## Service Bulletin

**SF-070**

SUBJECT: Drain Port on Inducer

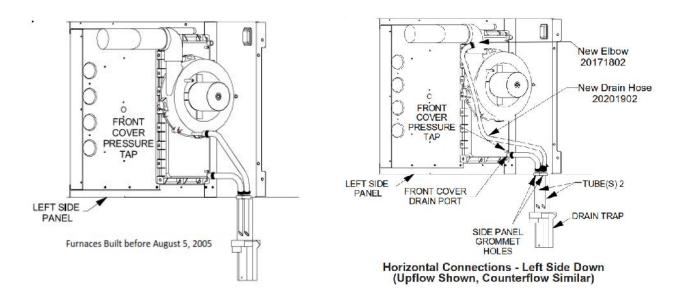
On 90% furnaces installed in the **Horizontal Left Position** manufactured before August 5, 2005, the vent condensate was removed through the drain port on the inducer housing. The current replacement inducer does not have the drain port on the inducer housing, so if you have to replace the inducer on furnaces manufactured before August 5, 2005 you will need to use the new drain elbow Part # 20171802 and drain hose Part # 20201902 to remove the condensate from the vent. Refer to instructions and illustration below.

- 1. Loosen the hose clamps and remove the old drain elbow.
- 2. Add the new drain elbow Part # 20171802S and reuse the old hose clamps and tighten.
- 3. Remove the plug from the drain port in the center of the drain elbow, add the dain hose Part # 20201902 and tighten field supplied hose clamp.
- 4. Attach the drain hose to the tube at the drain trap and tighten the field supplied clamp.
- 5. Refer to illustrations below.
